# Access Compliance Report

## Public Rights-of-Way

Intersection ID: 48608	Main Street: BULFINCH RD	Cross Street: PIEDMONT_ROW_DR	Location: SE
ADA ID: B5AC1192B78F	Ramp Type: Perp	Initial Pass/Fail: Fail	Overall Compliance: No
		Severity Score: 12.5

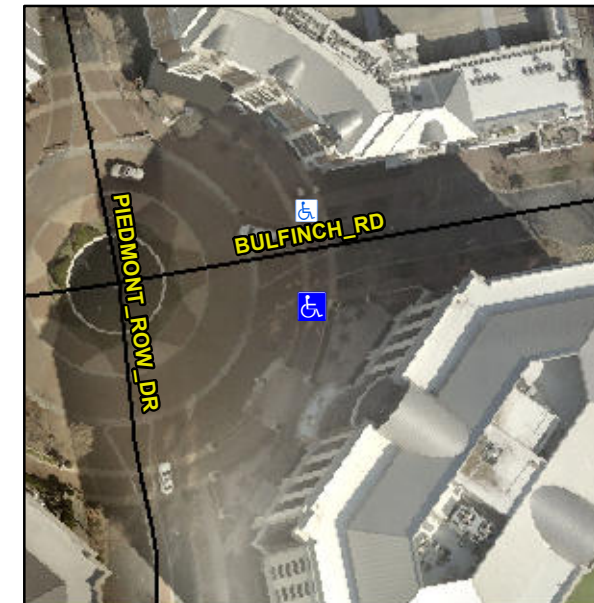
**R304.2.2**

Compliance	Description	Data	Compliance	Description	Data
N/A	Ramp Length (in)	126.0	No	Ramp Slope (%)	8.6
Yes	Ramp Width (in)	106.0	Yes	Ramp XSlope (%)	1.7
N/A	Flare Type LT	N/A	N/A	Flare Type RT	N/A
N/A	Flare Slope LT (%)	N/A	N/A	Flare Slope RT (%)	N/A
N/A	Flare Traversable LT?	N/A	N/A	Flare Traversable RT?	N/A
N/A	Landing Length (in)	N/A	N/A	DWS Provided?	N/A
N/A	Landing Width (in)	N/A	N/A	DWS Contrast?	N/A
N/A	Landing Slope (%)	N/A	N/A	DWS Length (in)	N/A
N/A	Landing X Slope (%)	N/A	N/A	DWS Full Width?	N/A
N/A	Landing Curb? (Y/N)	N/A	N/A	DWS Offset (in)	N/A
N/A	Shared Landing?	N/A			
N/A	Gutter Ponding?	N/A	N/A	Gutter Slope (%)	N/A
N/A	Gutter Lip Ht (in)	N/A	N/A	Gutter X Slope (%)	N/A
N/A	Painted X Walk1?	Yes	N/A	Painted X Walk2?	N/A
	X Walk 1 Direction	To N		X Walk 2 Direction	N/A
N/A	X Walk 1 Width (in)	123.0	N/A	X Walk 2 Width (in)	N/A
	X Walk 1 Slope (%)	1.4		X Walk 2 Slope (%)	N/A
	X Walk 1 X Slope (%)	0.3		X Walk 2 X Slope (%)	N/A

**Remove & Replace Entire Ramp.**
